Felix Buechi *et al.*  
Appl. No.: 10/608,088

**Amendments to the Drawings:**

Appl.No. 10/608,088  
 Reply to Office action of February 2, 2006  
 Annotated Sheet Showing Changes

Fig. 1 (Prior Art) *added*

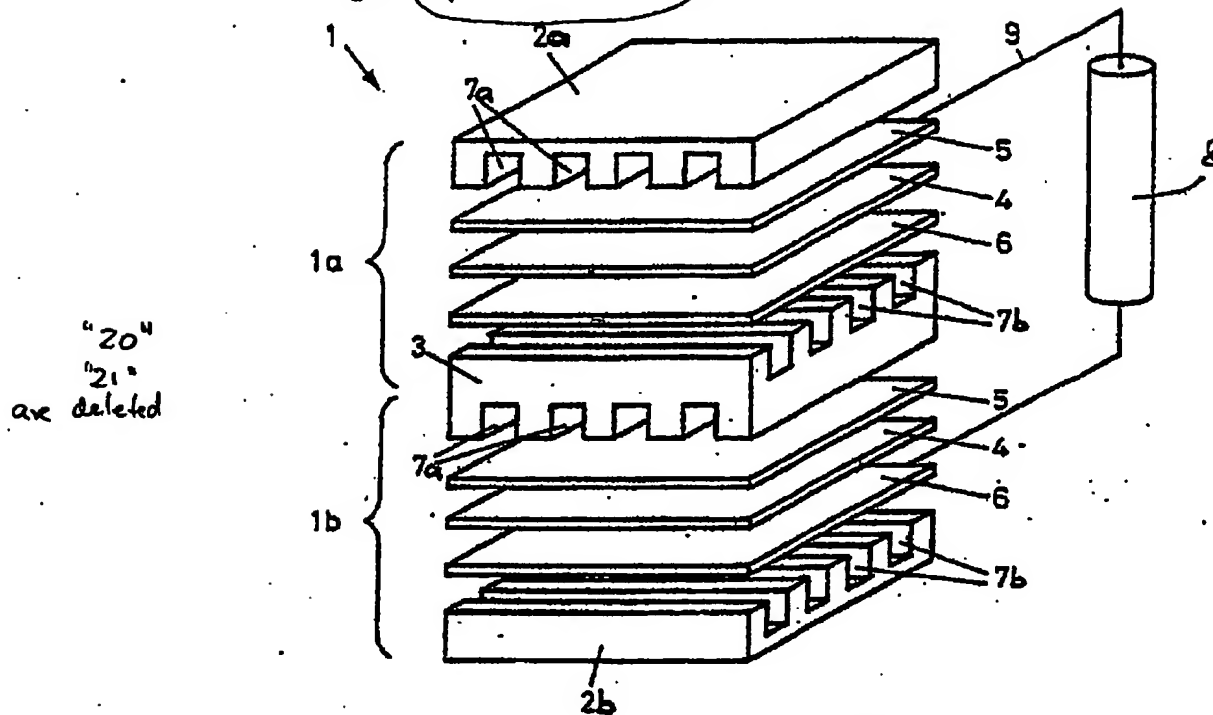
The Examiner objects to the drawings under 37 C.F.R. §1.84(p)(5) for showing reference numerals not mentioned in the description, and under 37 C.F.R. §1.84(p)(4) for improperly using reference numerals for different items. Further, the Examiner requests labeling Figures 1 and 2 as Prior Art.

In Figure 1, reference numerals 20 and 21 have been deleted.

Figure 1 has been labeled as “Prior Art.” Further, in Figure 1, reference numerals 20 and 21 have been deleted.

Fig. 2  
 (Prior Art)

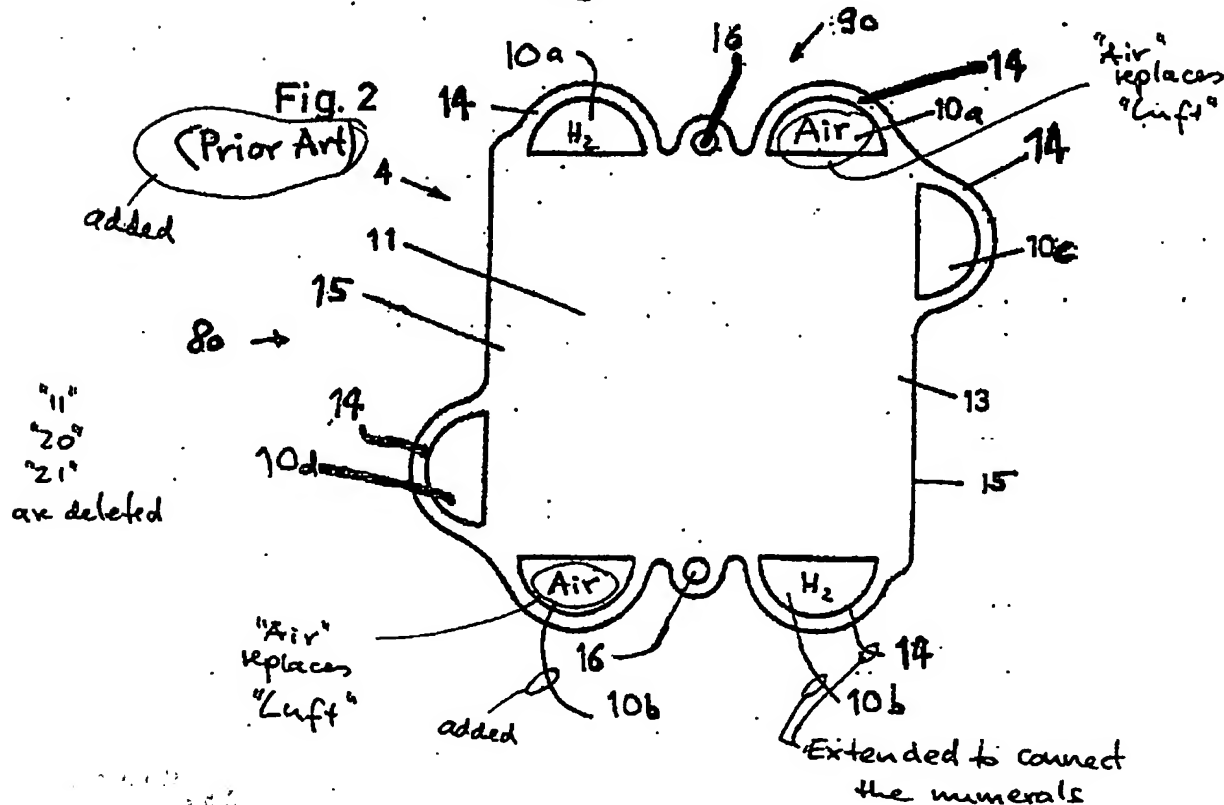
In Figure 2, reference numerals 11, 20 and 21 have been deleted. Lead lines and corresponding reference numerals have been clarified. German word "Luft" has been replaced by "Air."

Figure 2 has been labeled as “Prior Art.” Further, reference numerals 11, 20 and 21 have been deleted. Lead lines and corresponding reference numerals have been clarified. German word “Luft” has been replaced by “Air.”

Fig 3

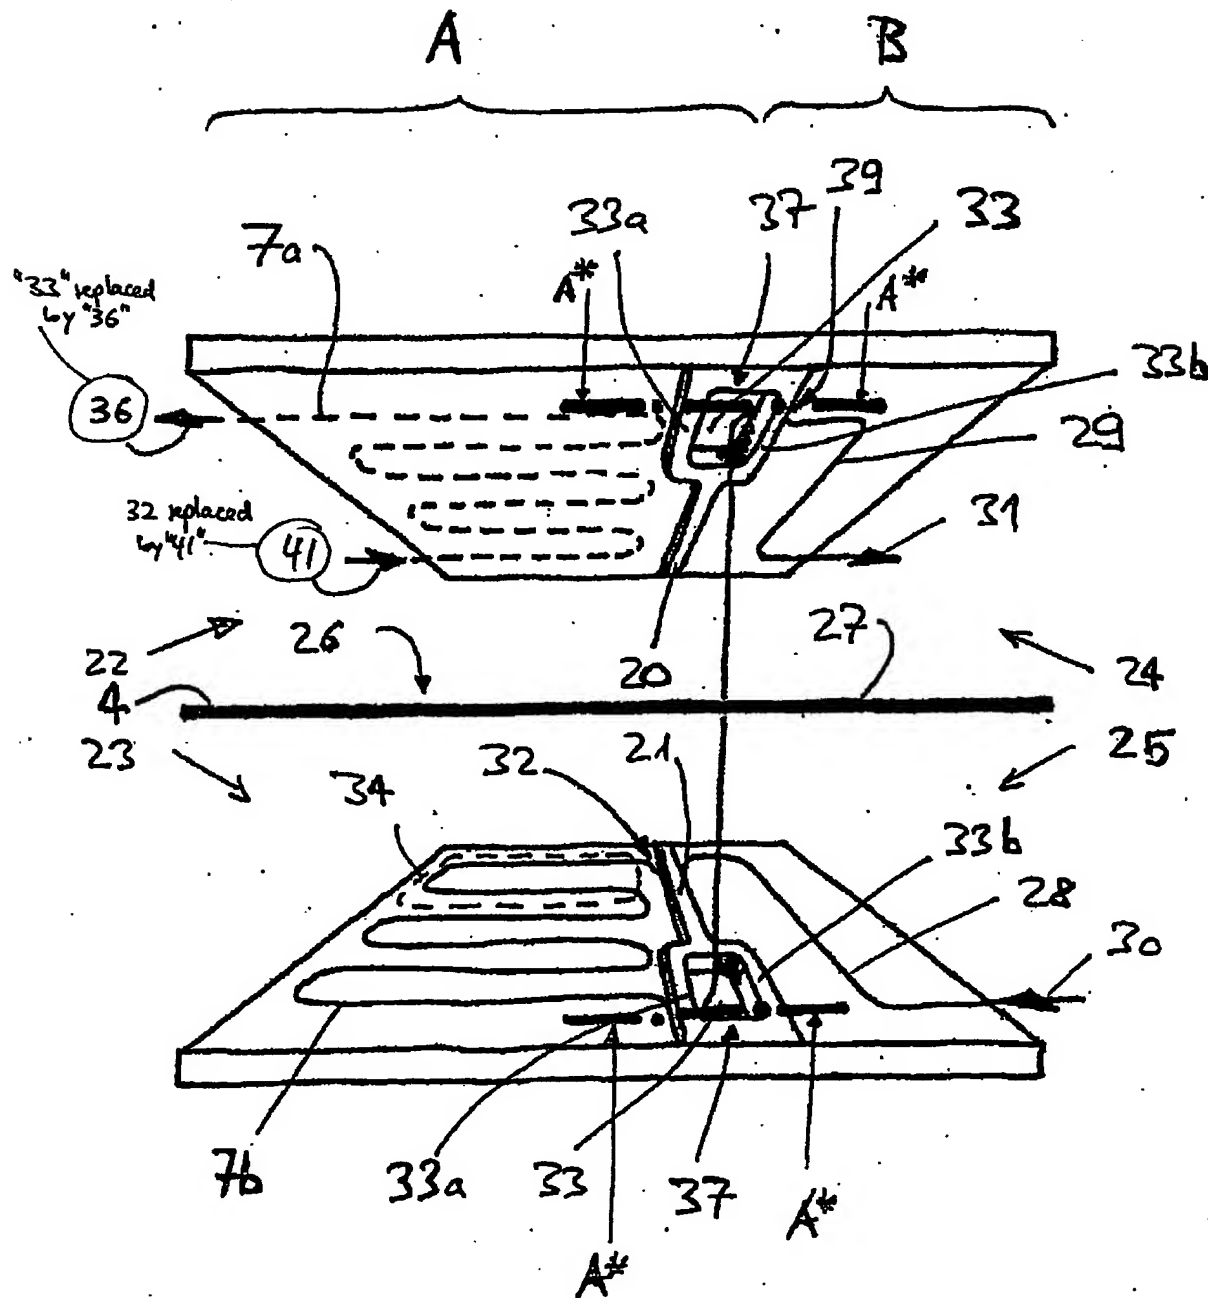
In Figure 3, arrows at the input and output of channel 7a have been labeled as 36, 41 to avoid double use of numerals 32, 33.

Figure 3 has been amended to label arrows as 36, 41 to avoid double use of numerals 32, 33.
